Burlington Design Advisory Board

DESIGN ADVISORY BOARD Tuesday September 22, 2020 3:00 PM REMOTE MEETING

MEMORANDUM

To: The Design Advisory Board
From: Ryan Morrison, Associate Planner
RE: ZP21-0099CA; 88 Locust Street
Date: September 8, 2020

New design
West elevation

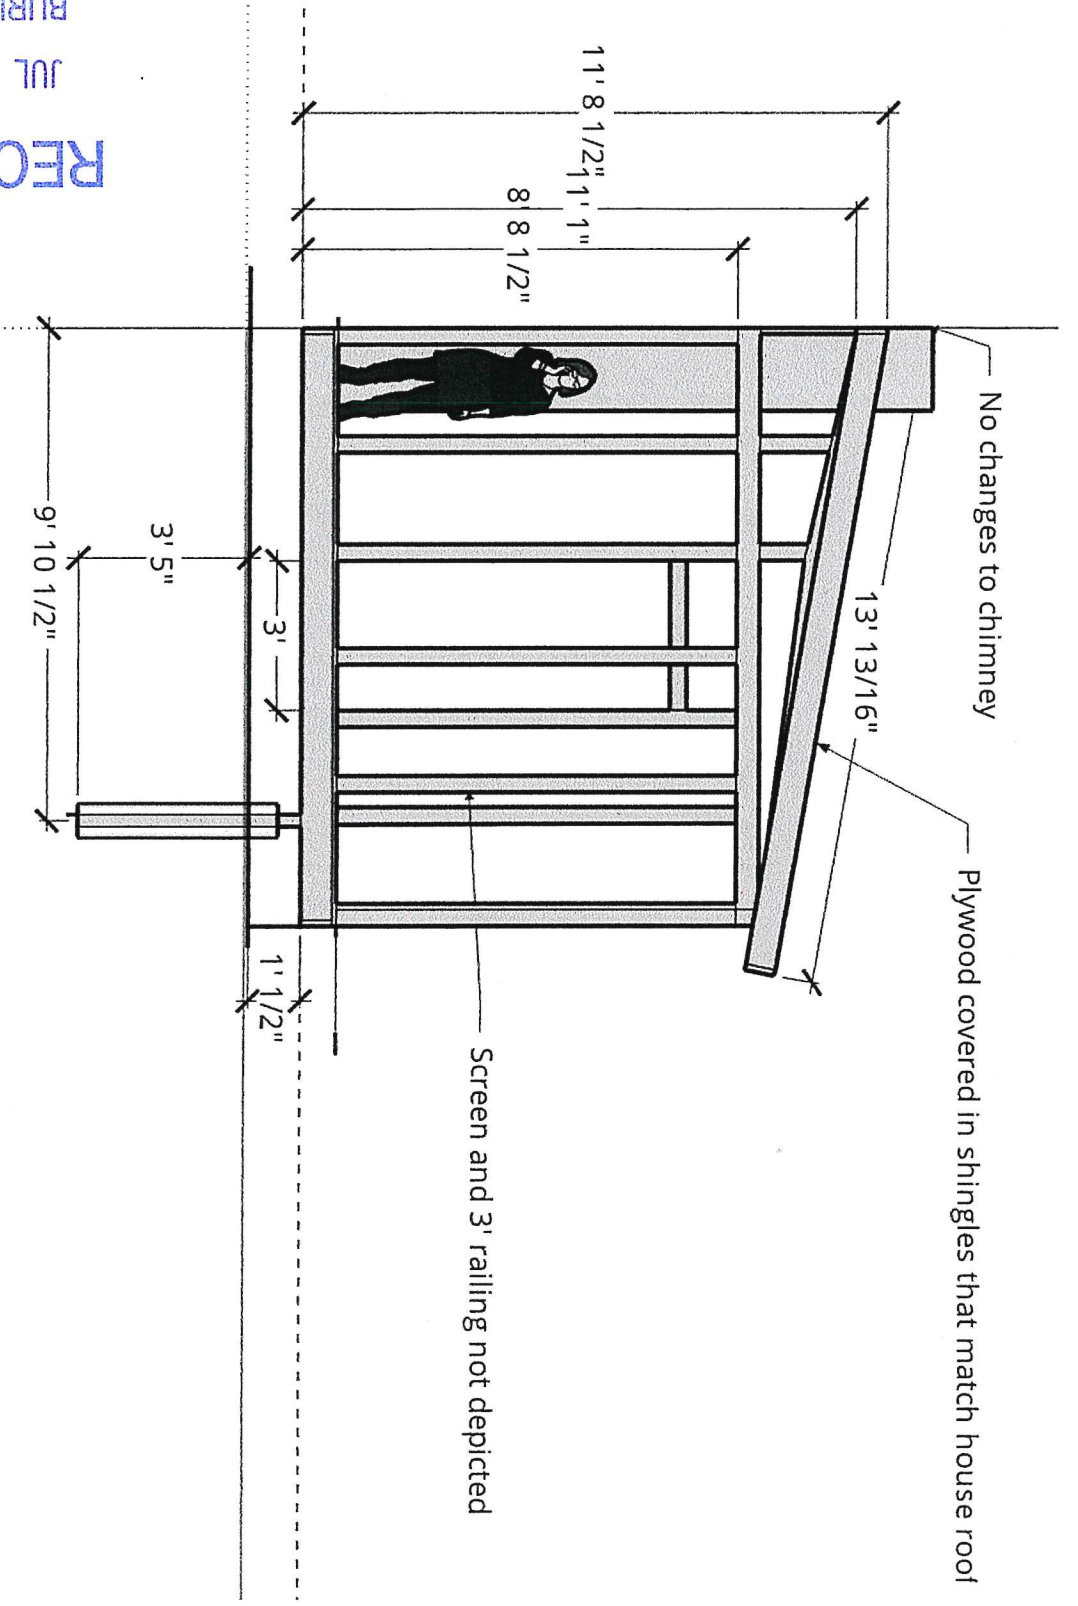
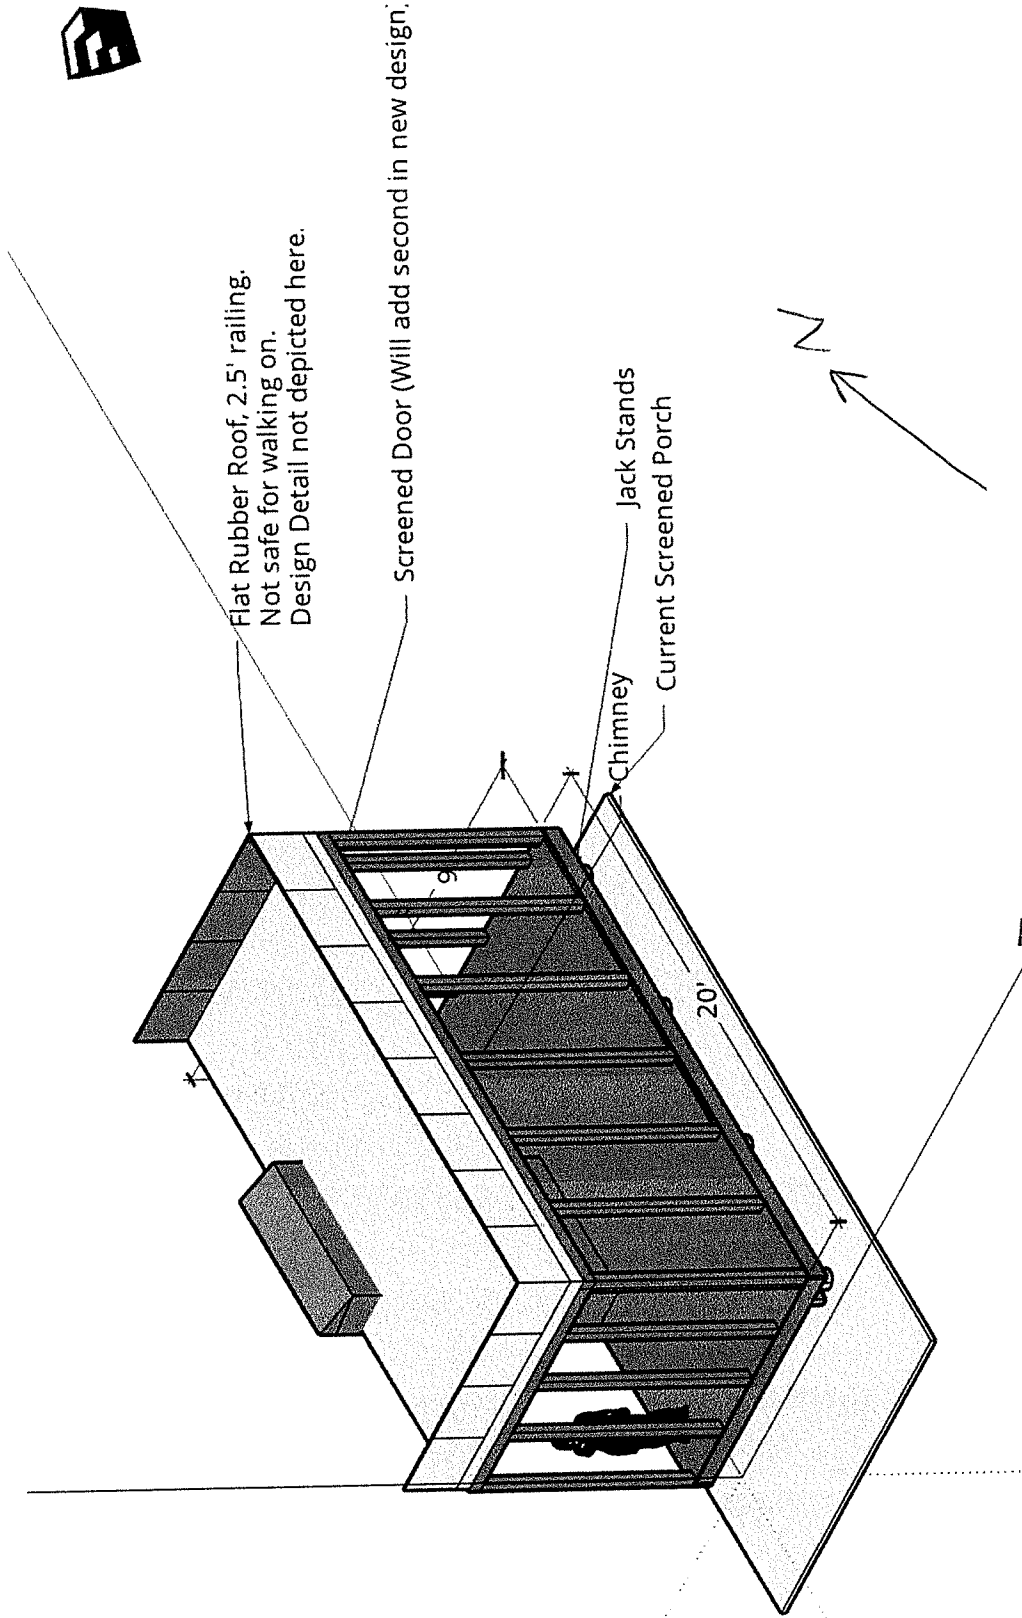
The existing porch roof is flat and has surrounding railings with a unique balustrade design. The applicant notes that the balustrade has a pinwheel motif that looks like a swastika, which is understandably upsetting if accurate. The replacement porch is proposed to have a sloped roof with no railings to aide with snow loads. With the omittance of rooftop railings from the proposed design, a historic feature of the historic porch will be lost.

maintain a similar appearance with that of the existing porch, with the exception of the roof. The applicant proposes a roof that is sloped (eastward) with no railings. With the lack of rooftop railings, a historic characteristic of the existing porch will be lost, which conflicts with this standard.

With the lack of a rooftop railing system on the replacement porch, an aspect of the historical appearance will be lost. As noted above, it appears feasible to add a rooftop railing to preserve the porch's historic appearance and to act as a screen to the sloped roof.

As noted above, the existing rooftop railing system will be lost with the replacement porch. It appears that a similar railing system could be included on the porch roof, and as an added bonus, could provide a level of screening to the sloped roof. The applicant proposes a sloped roof to aide with the snow load – with the idea that snow will slide off to the east.

- The existing porch has a rooftop railing system with intricately designed balustrades. The proposal omits rooftop railings. It appears that if similar railings were added to the new roof, they could provide partial screening to the sloped roof while maintaining a historic appearance. This would be of particular importance when considering its visibility from the street. The applicant's concern is in regard to snow loads, and the roof's ability to facilitate snow to slide off to the east. While a similarly designed railing would prevent snow from sliding off, perhaps the railing on the east side could be gate-like and allow for the property owner to open it and allow for easy snow removal.
- The proposal should include landscaping around the new porch.
- With the exception for non-visible substructure, the replacement porch shall not utilize pressure treated materials.

Existing design
North elevation

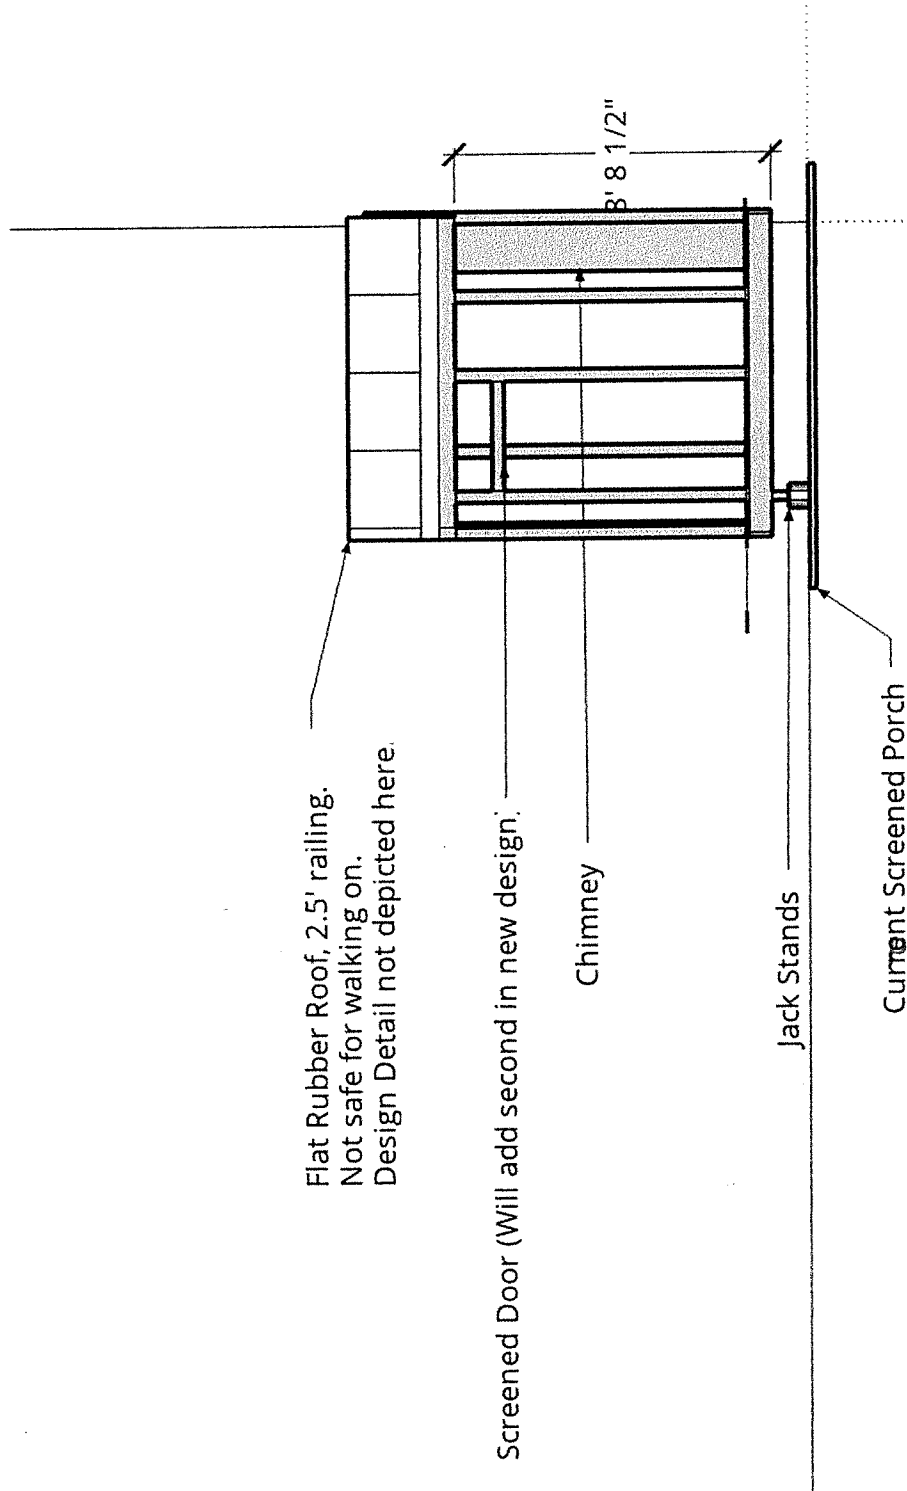
It is likely that the existing porch was added after initial construction of the home. However, its rooftop railing has historic relevance. While the majority of the replacement porch will maintain a similar appearance with the existing, the lack of a similar rooftop railing system will be a detriment to the property's historic nature.

With the exception of the rooftop, the replacement screen porch will maintain the appearance and design of the existing porch. The main question is: should it be allowed as proposed with no rooftop railings?
